## **MAIN ROTOR BLADE ABRASION STRIP DAILY INSPECTION REQUIREMENTS**

This document supersedes 2100-8R2, adds additional figures to aid in the inspection process, and changes this document to Mandatory Service Bulletin.

**Mandatory  
Service Bulletin**

Figure 1 – 1.25 inch (31.8 mm) Chord Abrasion Strip

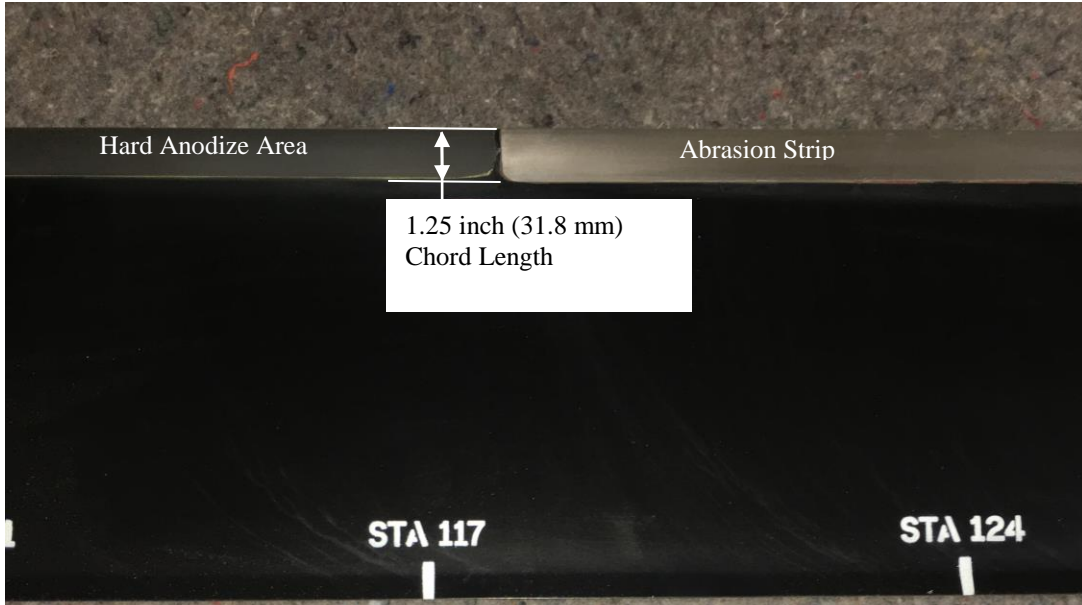
- 1) Determine which Chord Length Abrasion Strip is present on the subject blade and Total Time Since New (TTSN) or since Abrasion Strip Replacement to determine if this Mandatory Service Bulletin is applicable. Reference **Figure 1** and **Figure 2** on Page 2.

- 1) If applicable, Fielded Main Rotor Blades are to be returned to the HTC Factory or an HTC Authorized Repair Station qualified to perform this modification. This modification consists of the removal and replacement of the Abrasion Strip with a 0.88 inch (22.4 mm) chord Stainless Steel Abrasion Strip in accordance with HTCQ-004, Revision I (or later approved revision) Standard Repair Instruction – Main Rotor Blade. Installation of the 0.88 inch (22.4 mm) chord Stainless Steel Abrasion Strip shall constitute compliance and repeating **PART 1** is no longer required.

Figure 3 – Inboard Abrasion Strip Area

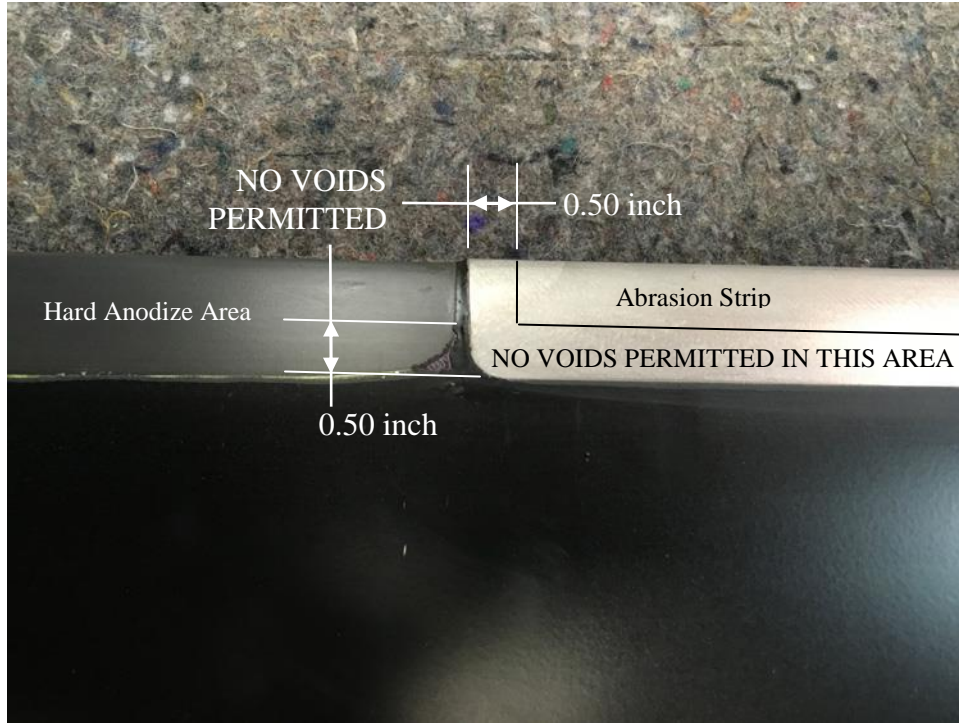
- 5) If any Void is found within 0.50 inches (12.7 mm) of any edge regardless of size, replace the subject blade with another airworthy blade, Reference **Figure 3** and **Figure 4** on Page 5. **Note: Do not attempt a field repair.**
